BASTION PARK - CONCEPTUAL MASTER PLAN OVERVIEW & ENGAGEMENT SUMMARY

VILLAGE OF HAZELTON

OCTOBER 9, 2020

SECTION B - TRAIL REALIGNMENT, RESURFACING & CONNECTION

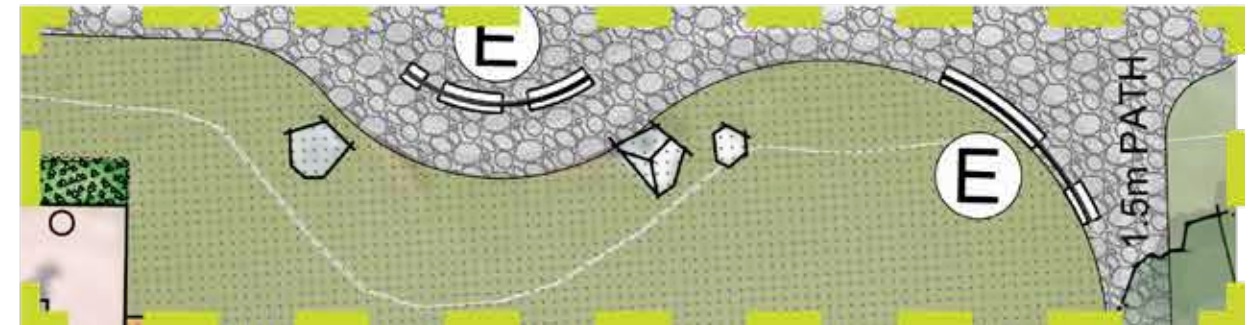
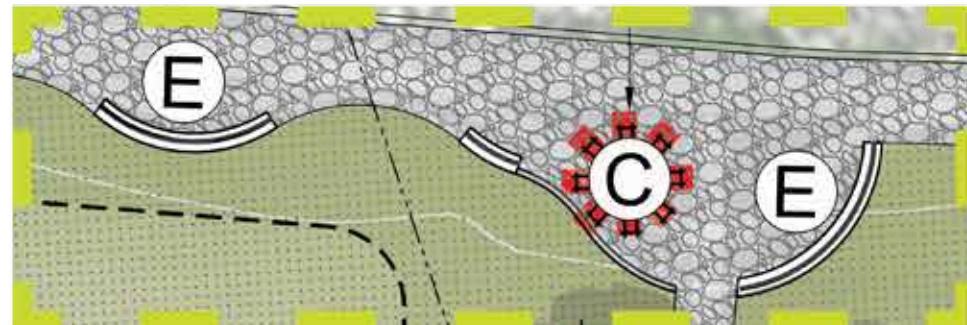
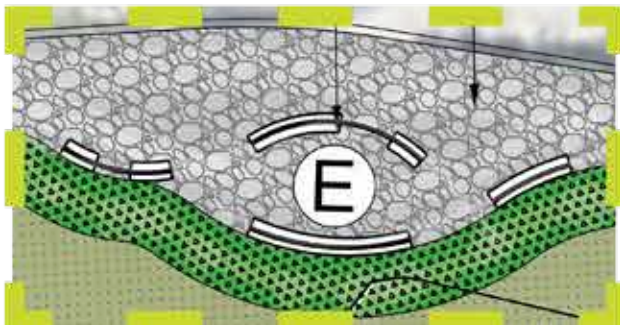
- Support for public art along trail
- A preference for the look of wood boardwalk (compacted gravel was shown in the concept with long-term maintenance in mind)
- Agreement that ramps are a priority for accessibility

1. “Public art here is fine.”
2. I like the idea of improving the trail. I like the look of the wooden boardwalk rather than crushed rock.
3. Ramps are very important to provide better accessibility for elders and families with young children.

SECTION D - SIDEWALK WIDENING & STREET IMPROVEMENTS

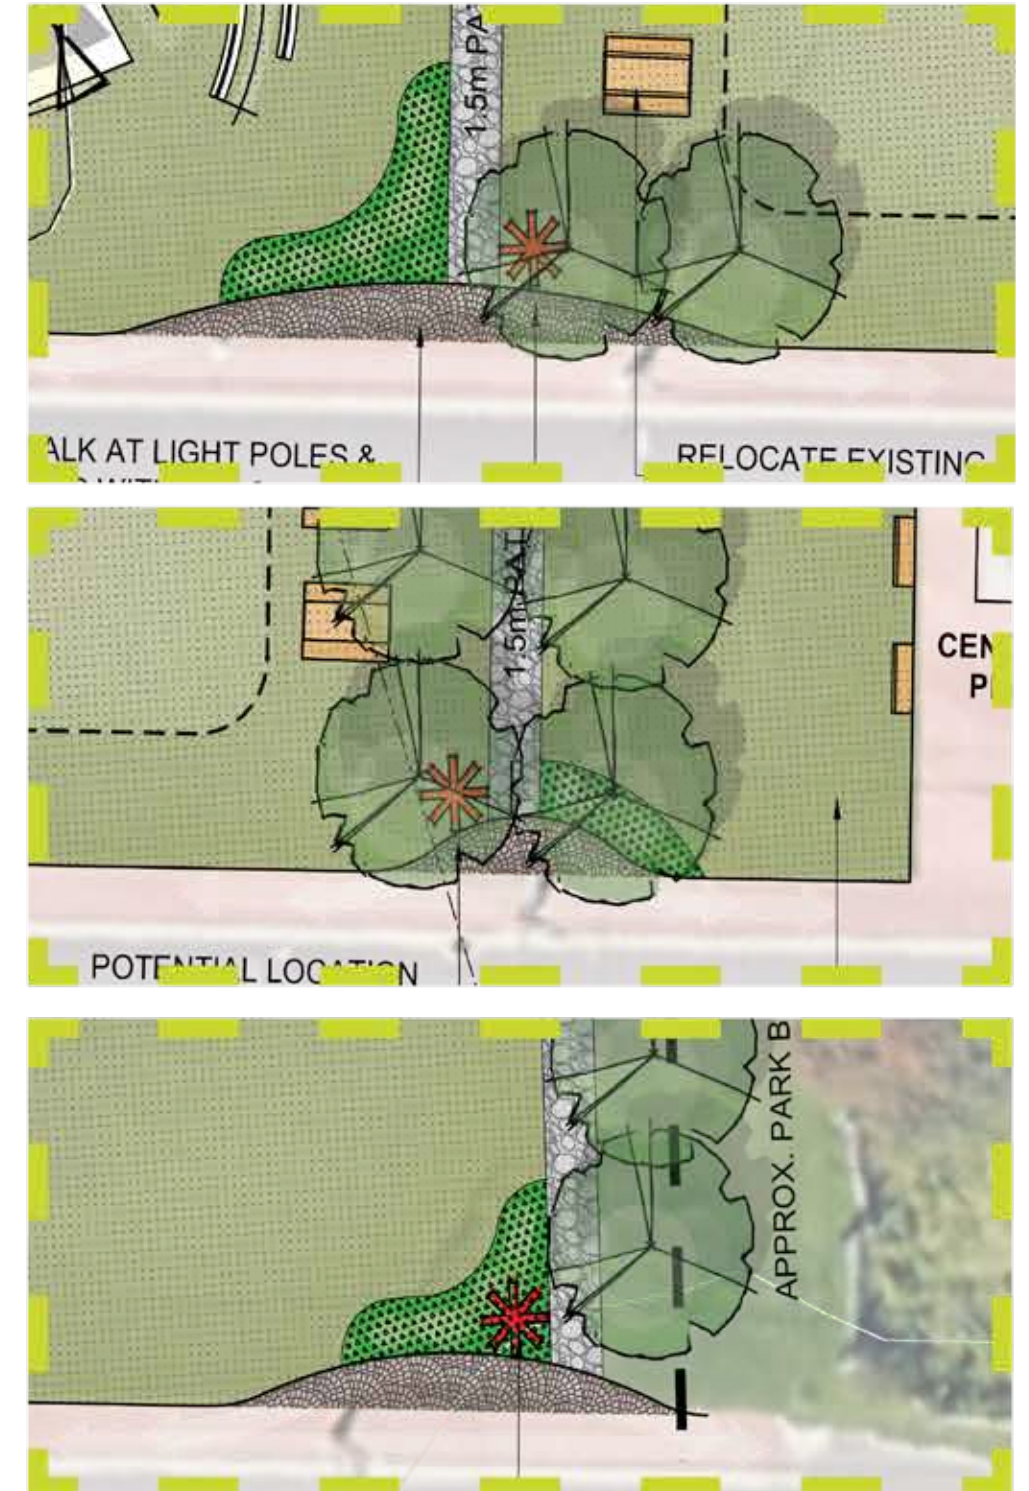
Sidewalk widenings received a high level of support as well, but respondents did not leave specific comments on the crowdsource site.

No additional comments were received regarding Sidewalk Widening and Street Improvement.
